Rezoning Transportation Analysis

Petition Number: 2023-134

General Location Identifier: 17125615, 17125616

Date	Description
11-21-23	First Review (NK)
12-20-23	Second Review (NK)
1-24-24	Third Review (NK)

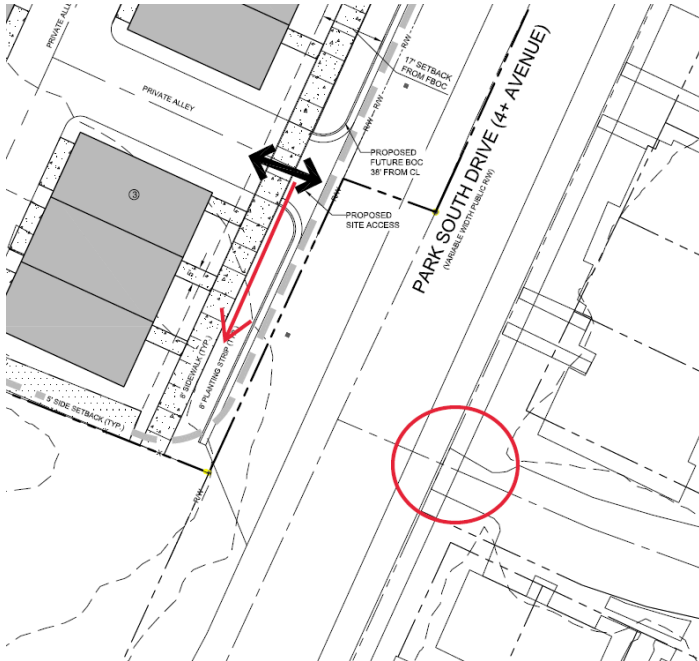
~~4. Revise site plan and conditional note(s) to commit to construct bicycle facilities by locating the curb and gutter 38' from the center line.~~

~~**Clarifying Comment 12/20/23:** Dimension for proposed BOC to CL needs to be shown on the plans as well as the buffered bike lane that is required per the Charlotte Street Map cross section.~~

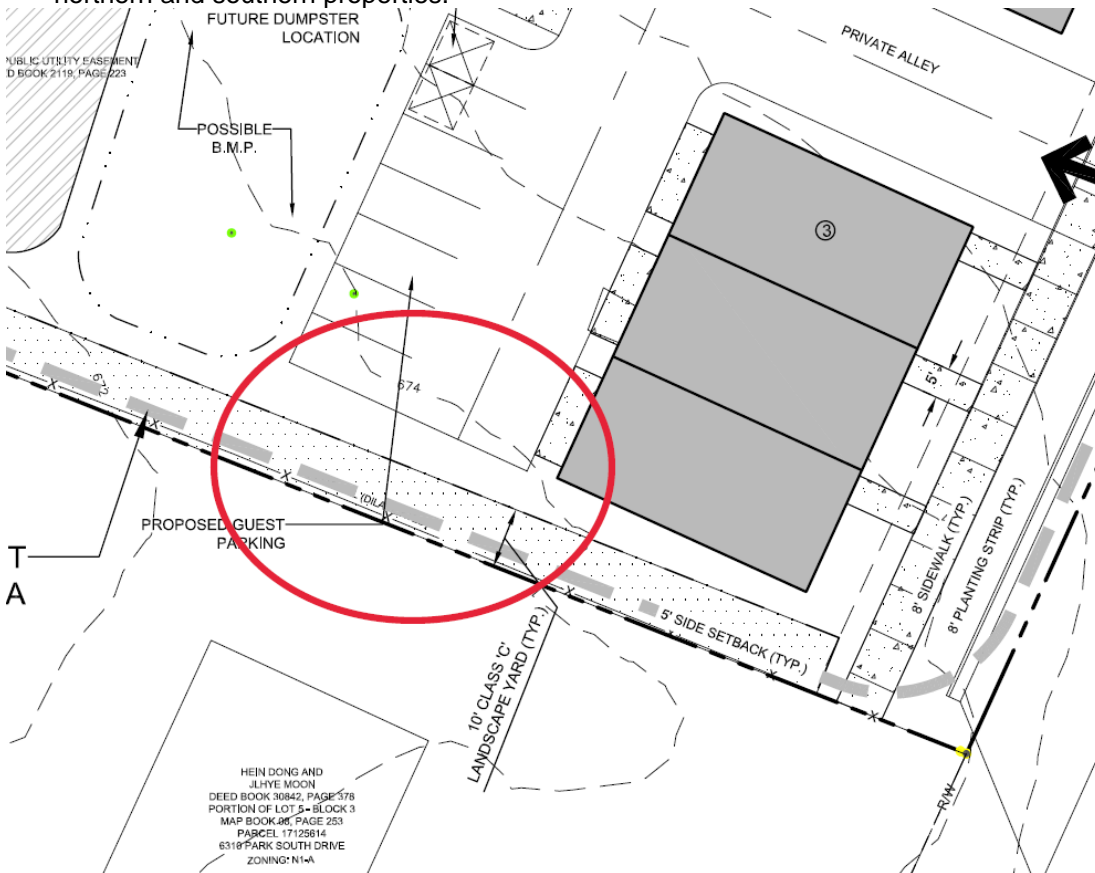
~~5. Revise site plan and conditional note(s) to commit to aligning driveway with the driveway located on the opposite property~~
